Post-Closure Inspection and Monitoring Report for Corrective Action Unit 417: Central Nevada Test Area Surface, Hot Creek Valley, Nevada, for Calendar Year 2007

September 2008

Rev. 1

Due Date 08/15/08	Review No. 1	Project Legacy Management	Type of Review Technical
Document Title and/or Number and Revision Post-Closure Inspection and Monitoring Report for Corrective Action Unit 417: Central Nevada Test Area Surface, Hot Creek Valley, Nevada for Calendar Year 2007			Reviewers' Recommendation <input type="checkbox"/> Release Without Comment <input type="checkbox"/> Consider Comments <input type="checkbox"/> Resolve Comments and Reroute for Review <input type="checkbox"/> Comments Have Been Addressed <input type="checkbox"/> Comment Resolution Satisfactory <input type="checkbox"/> Comment Resolution Unsatisfactory
Author Paul S. Darr			
Author's Organization		Author's Phone (970) 248-7666	
Reviewer Tim Murphy			
Reviewer's Organization NDEP		Reviewer's Phone (702) 486-2850	_____ <i>Signature of Reviewer and Date</i> _____ <i>Signature of Author and Date</i> _____ <i>Signature of Reviewer and Date</i>

Figure 3–3. UC-4 Cover Settlement

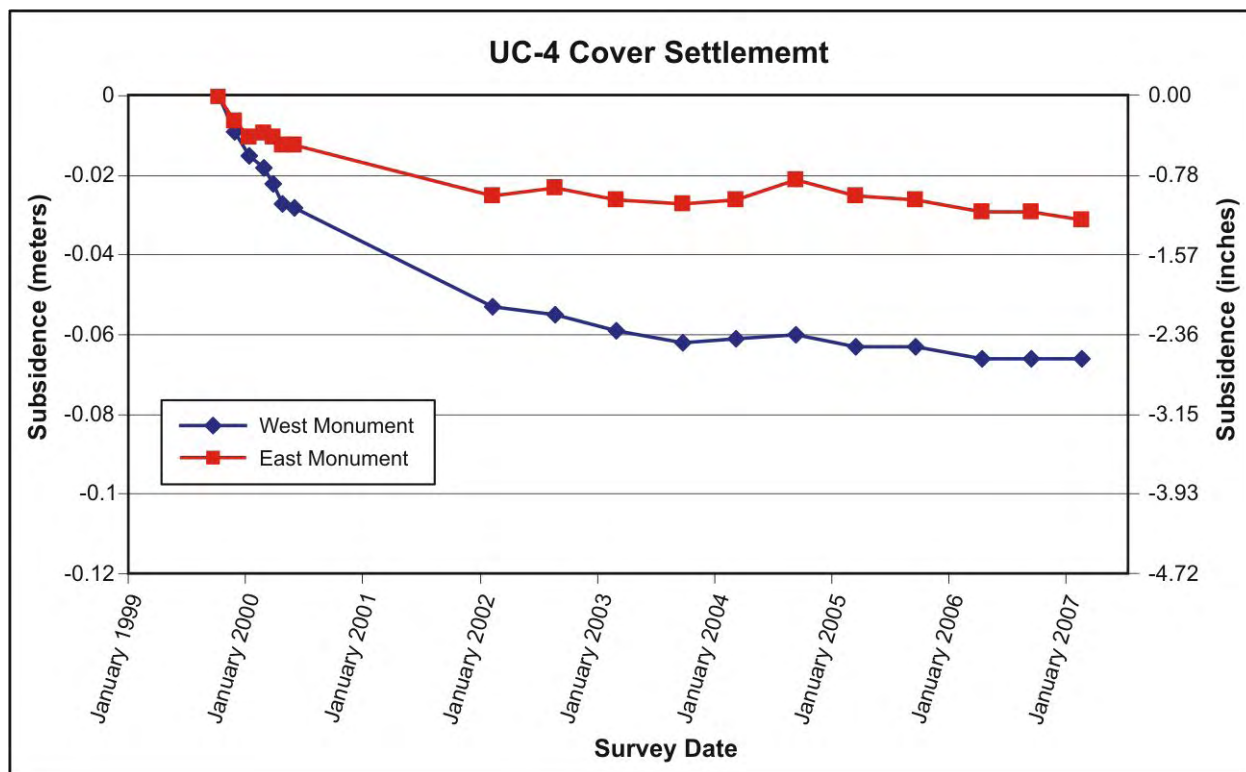
3. Section 3.2.2 and Figure 3.3: It is stated in Section 3.2.2 that the total subsidence of the west monument is 6.6 cm (2.6 in) and the east monument, 3.1 cm (1.2 in) since the baseline survey in October 1999. Figure 3.3 depicts the subsidence of the west monument as approximately 0.6 m or 2.6 inches but the east monument as approximately 0.9 m or 3.85 inches. The text of Section 3.2.2 and Figure 3.3 should be in agreement.

4. Page 3-6, Table 3-2 and Page 3-7, Figure 3-3: The values for east monument subsidence presented in Table 3-2 are not reflected in the plot in Figure 3-3. Please correct this discrepancy.

Review No.		Project		
Item No.	Reviewer's Comments and Recommendation	Reqd. (Y/N)	Item No.	Author's Response (if required)
				subsidence because of the thinner layer of underlying mud along this margin of the cover."
3	Section 3.2.2 and Figure 3.3: It is stated in Section 3.2.2 that the total subsidence of the west monument is 6.6 cm (2.6 in) and the east monument, 3.1 cm (1.2 in) since the baseline survey in October 1999. Figure 3.3 depicts the subsidence of the west monument as approximately 0.6 m or 2.6 inches but the east monument as approximately 0.9 m or 3.85 inches. The text of Section 3.3.3 and Figure 3.3 should be in agreement.		3	Figure 3.3: The east subsidence marker's graphical representation was incorrect and has been corrected.
4	Page 3-6, Table 3-2 and Page 3-7, Figure 3-3: The values for east monument subsidence presented in Table 3-2 are not reflected in the plot in Figures 3-3. Please correct this discrepancy.		4	Figure 3.3: The east subsidence marker's graphical representation was incorrect and has been corrected.

Figure 3–4. 2007 Precipitation Data

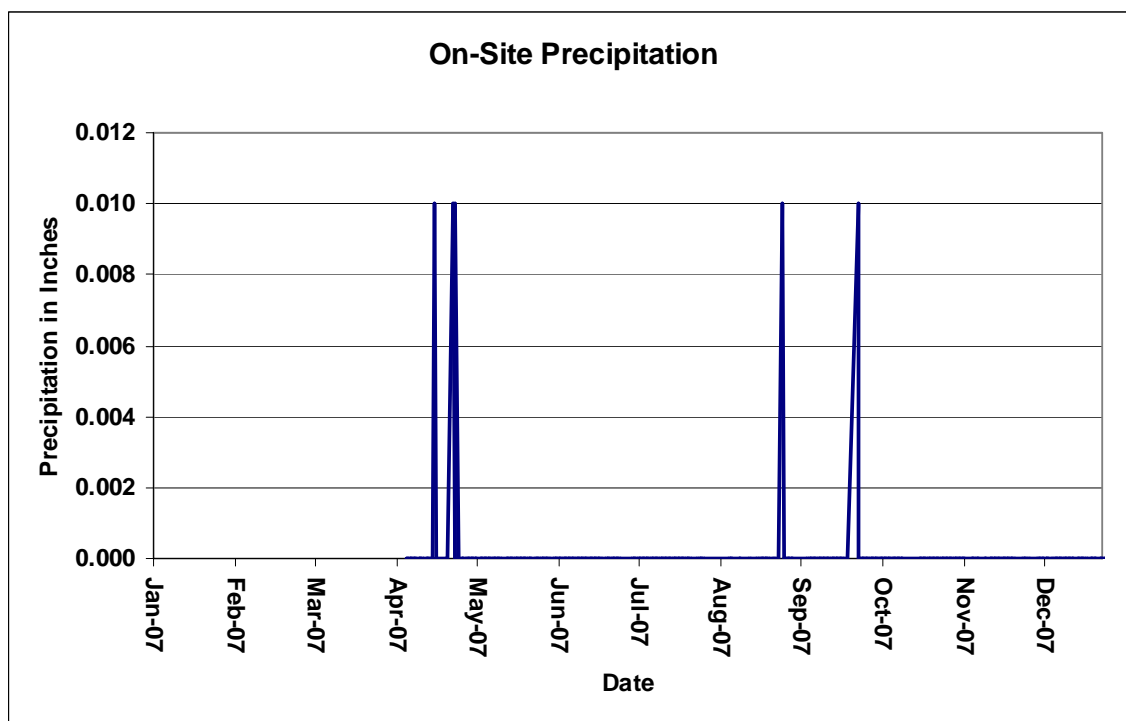
5. Page 3-8, Section 3.4, third paragraph, first sentence: There is no Figure 4-1 in the document. The 2007 precipitation is presented in Figure 3-4. Please correct this in the document.

5	Page 3-8, Section 3.4, third paragraph, first sentence: There is no Figure 4-1 in the document. The 2007 precipitation is presented in Figure 3-4. Please correct this in the document.			Page 3-8, Section 3.4, third paragraph, first sentence: Figure 4-1 has been changed to Figure 3-4.
6	Section 4.1 and Section C3.0: It is suggested in the second paragraph of Section 4.1 that future vegetation surveys be conducted once every 2 years or as needed to help monitor the health of the vegetation. The last paragraph of Section C3.0 also conveys this recommendation. This recommendation was presented in the Post-Closure Inspection and Monitoring Report for Calendar Year 2006 and approved by the NDEP in a letter dated August 2, 2007. The NDEP still accepts this recommendation and expects that a vegetation survey will be conducted during the 2008 inspection.			Currently, a vegetation survey is being conducted every two years. Due to the timing of the NDEP response approving this in August 2007, the DOE had already performed a vegetation survey in 2007. The next vegetation survey will be in 2009.
